CHAPTER 9. CLARIFICATIONS AND REVISIONS TO THE DRAFT EIR

9.1 Introduction

9.2 Clarifications and Revisions

Figure 4.1.2-1. Alternative 2 Plan

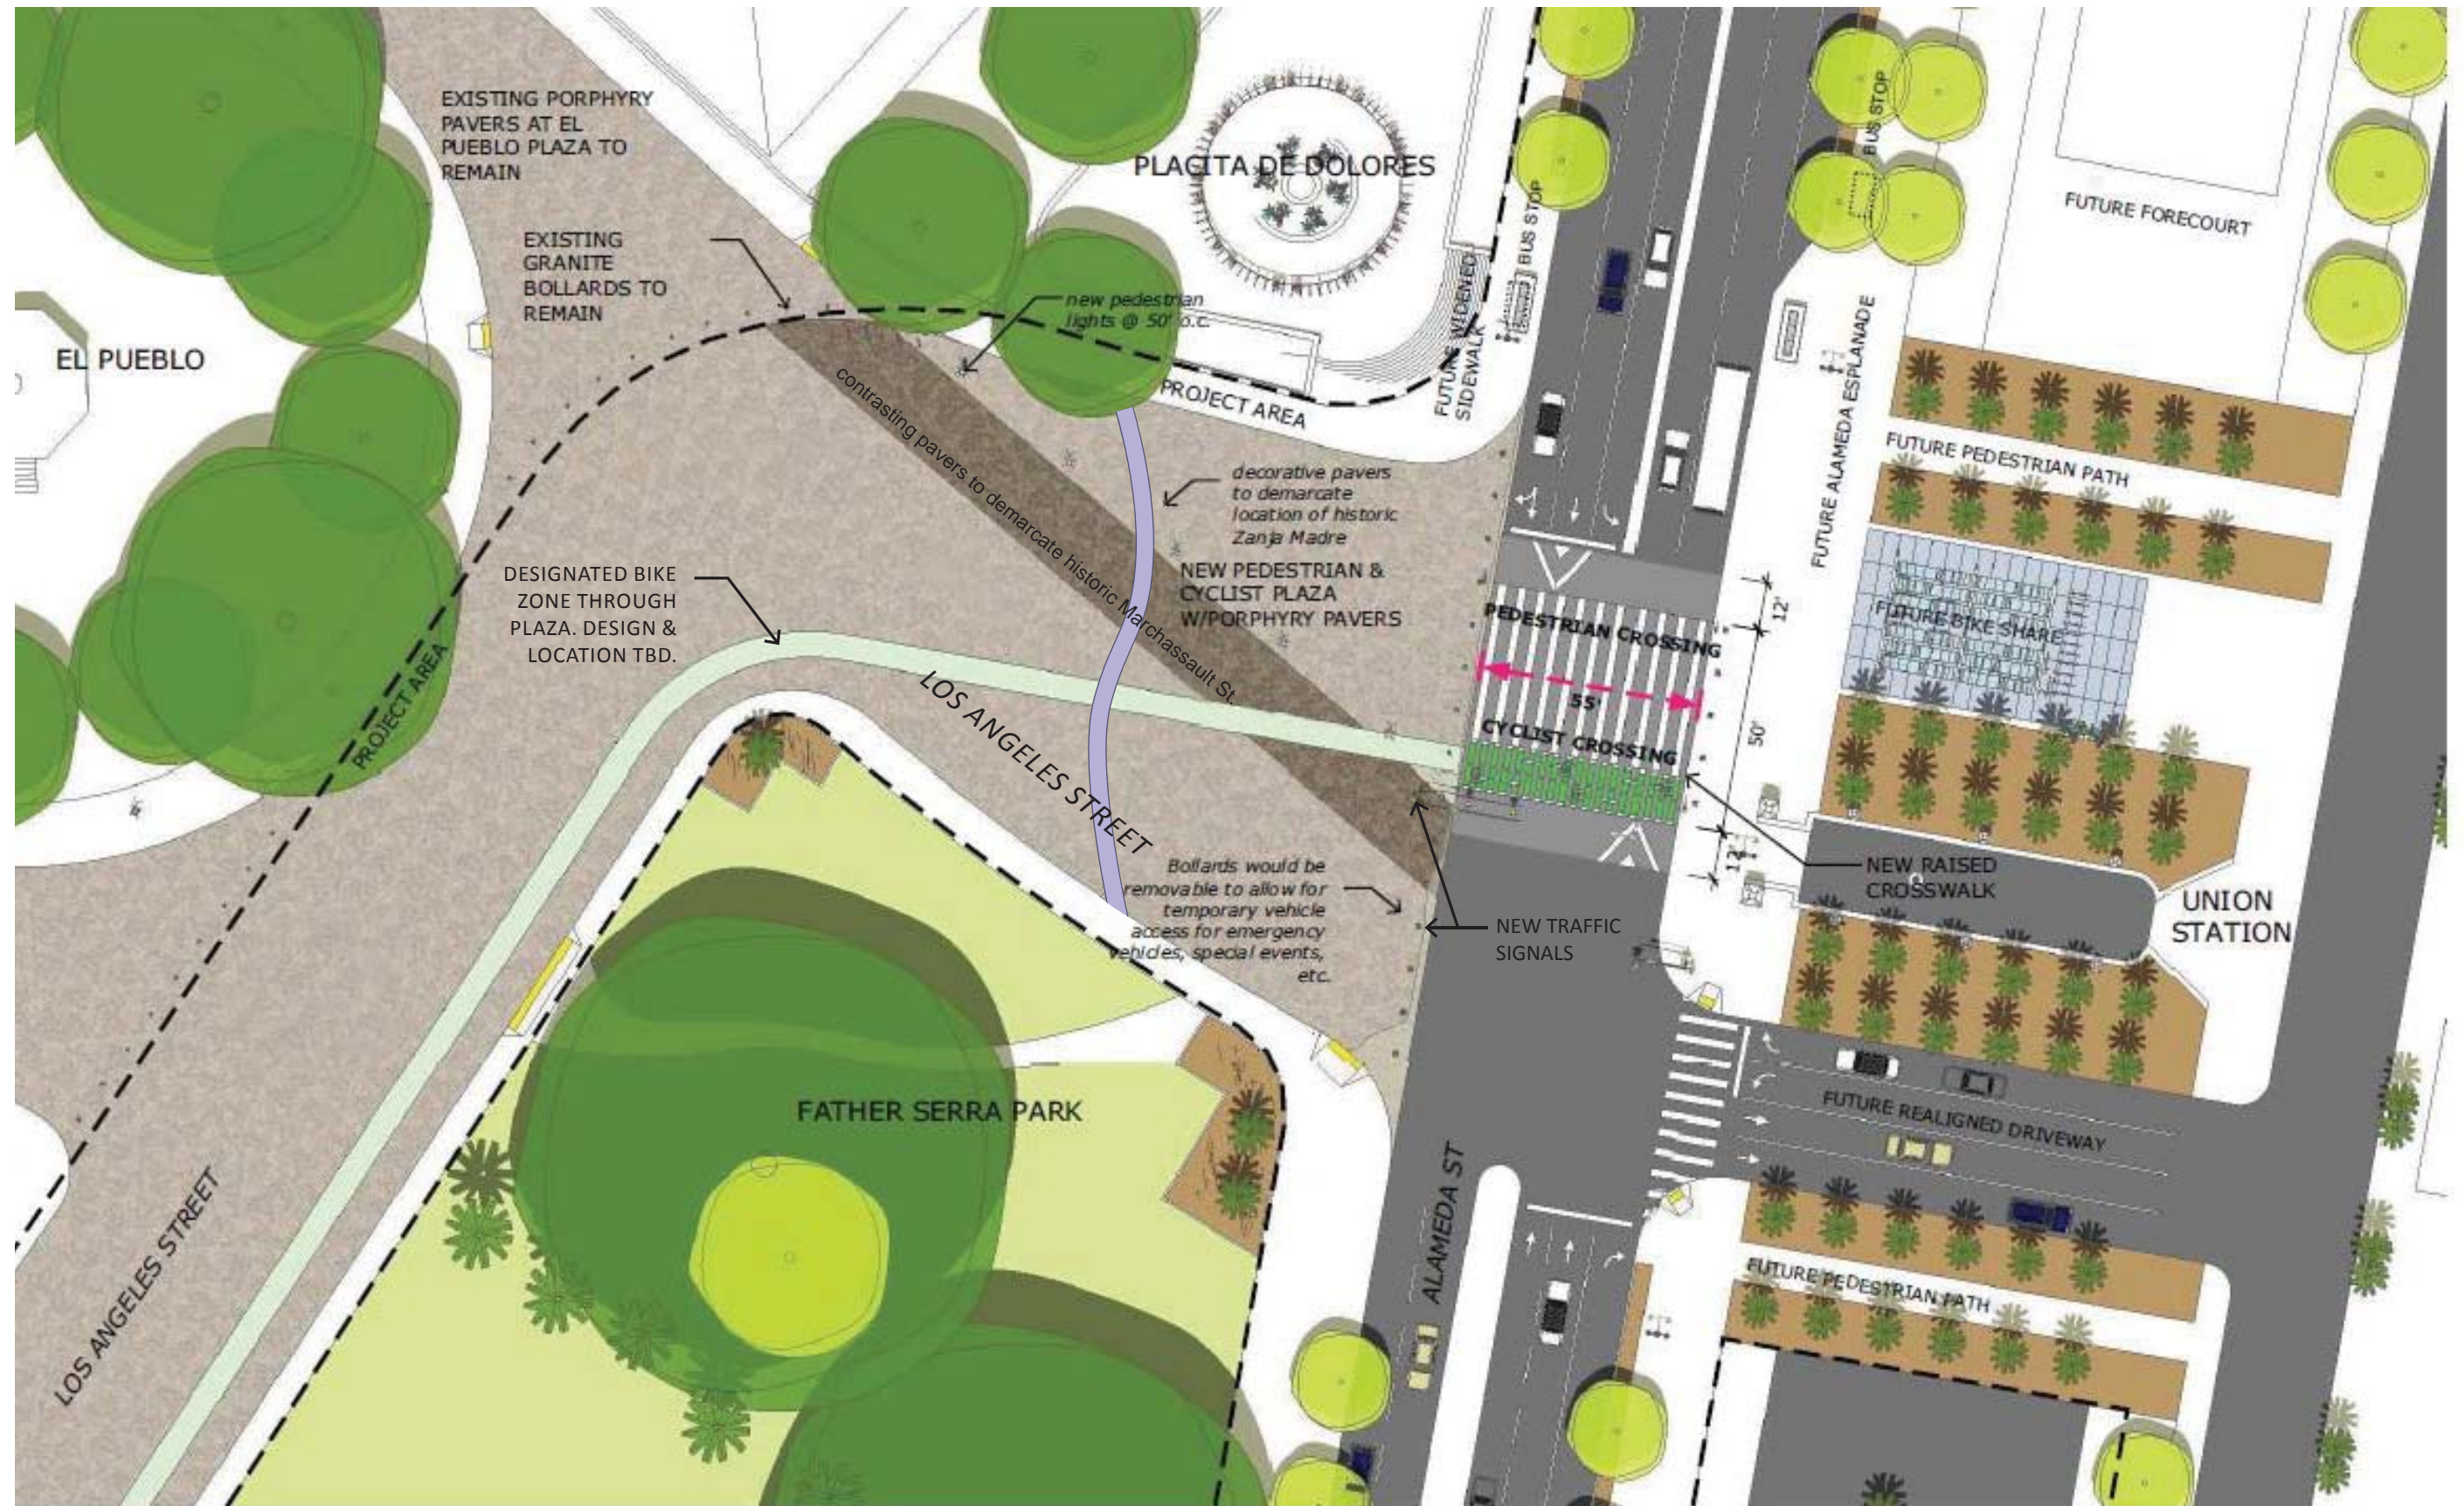
Page 4-2: Figure 4.1.2-1, *Alternative 2 Plan*, following this page, has been revised to include a callout to a designated bike zone through the plaza. Also, the figure has been revised to remove callouts on Los Angeles Street for the bus drop-off, continental crosswalk, and bollards within the plaza, which would not be used under the full closure of Los Angeles Street.

Page 4-2: Figure 4.1.3-1, *Alternative 3 Plan*, following this page, has been revised to include a two way, off street bicycle path within the expanded El Pueblo plaza near the west side of Los Angeles Street.
